**DEFECT INFORMATION REPORT FOR DAIMLERCHRYSLER RECALL D30**

## **Safety Recall D30**

# **Shoulder Belt Adjuster Turning Loop Bolts**

2005 (LX) Chrysler 300 and Dodge Magnum

Figure 1 – Passenger Side Shown

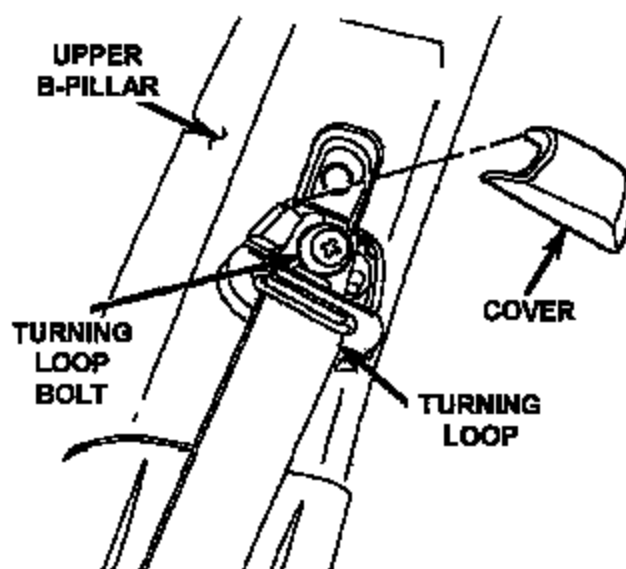
1. Using a trim stick placed between the turning loop cover and the release button, pry the top of the driver's side turning loop bolt cover open and then remove the cover (Figure 1).
2. Tighten the turning loop bolt to 30 ft-lbs (40 N·m).
3. Install the turning loop bolt cover by aligning catches on the bottom of the cover with the turning loop bracket and then snapping the cover over the top of the bracket. Ensure that the cover is fully installed.

**NOTE:** There should be no gap between the turning loop cover and the turning loop. Pinch the turning loop and cover with your finger and thumb to fully seat the cover.

**NOTE:** If the turning loop cover was damaged during removal, replace it with a new cover (P/N 5HF07BD1AC).

4. Repeat Steps 1-3 for the passenger side turning loop bolt.
